Beaver Valley Power Station, Unit No. 1  
Proposed Technical Specification Change No. 192

### Beaver Valley Power Station, Unit No. 1 Proposed Technical Specification Change No. 192 REVISION OF TECHNICAL SPECIFICATION 3.7.1.2

Proposed Revisions to the Inservice Testing Program for Pumps and  
Valves

1FW-P-2  
MOP CURVEDERIVED AS 90% OF MANUFACTURER'S TEST CURVE.  
PER CALCULATION #8700 24.46 REV 0.

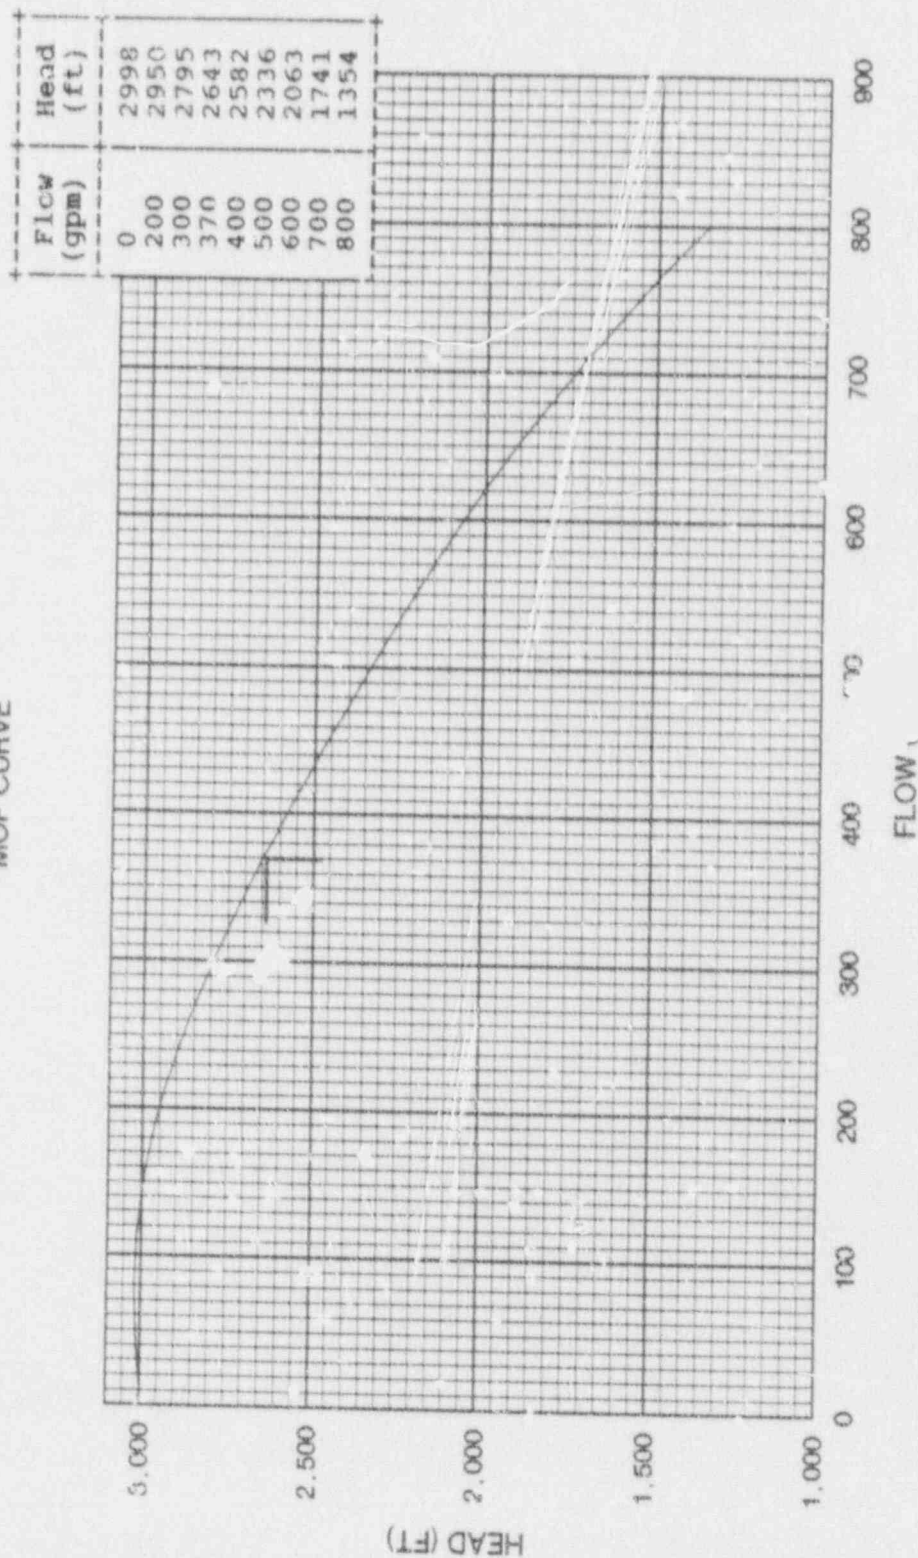
The proposed change to SR 4.7 1.2.a would delete the reference to this specific test point. The proposed wording for SR 4.7.1.2.a allows the AFW pumps to be tested at any point from complete recirculation to full flow conditions. The curve which will define whether the AFW pumps develop the specific head required to meet safety analyses will be the individual MOP curve for each AFW Pump. Each MOP curve will be contained in the IST Program and controlled in accordance with program requirements. A draft revision to the IST program is contained in Attachment B-1 for informational purposes. Future changes to these MOP curves, if this amendment request is approved, will be made as necessary through the 10 CFR 50.59 process and will be sent to the Nuclear Regulatory Commission (NRC) as part of revision updates to the IST Program.

The "Pump Minimum Operating Point (MOP) Curves" section contains a graphical representation of the minimum allowable pump flow versus head which is required to meet applicable safety analyses for each pump in the Unit 1 IST Program.
